Detailed Site Plan Knox Road

DSP-19037

REQUEST	STAFF RECOMMENDATION
A mixed-use building with 343 multifamily dwelling units and 23,847 square feet of ground floor commercial retail.	APPROVAL with conditions

SUBJECT: Detailed Site Plan DSP-19037
Knox Road

BUILDING ELEVATIONS

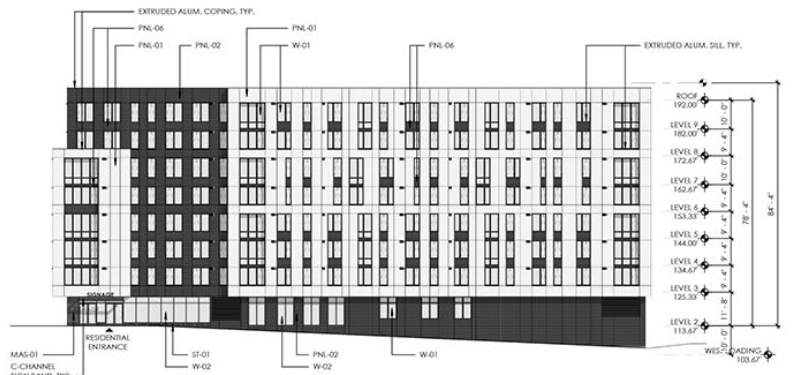
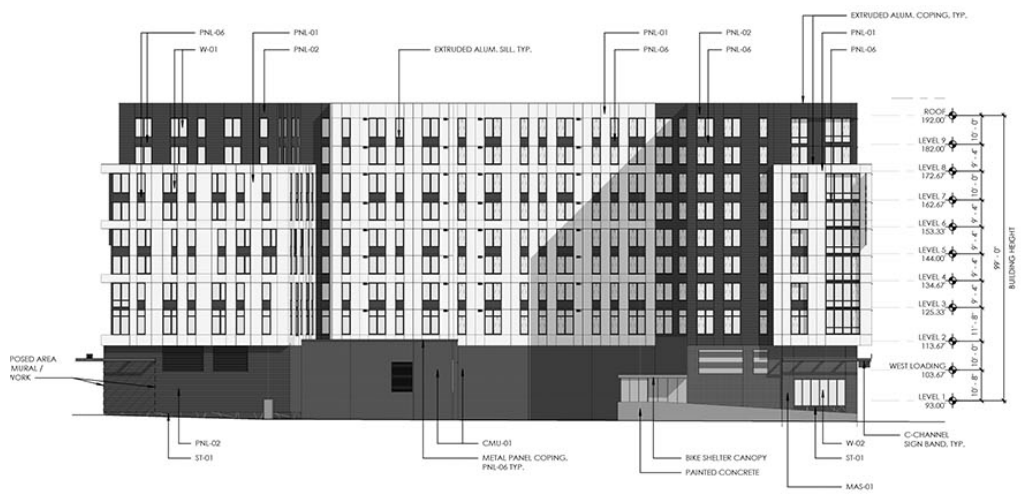
- c. Revise the architecture to provide a minimum five-foot building step back for each story over the six stories allowed in the Development District Overlay Zone to reduce the impact of the additional height.
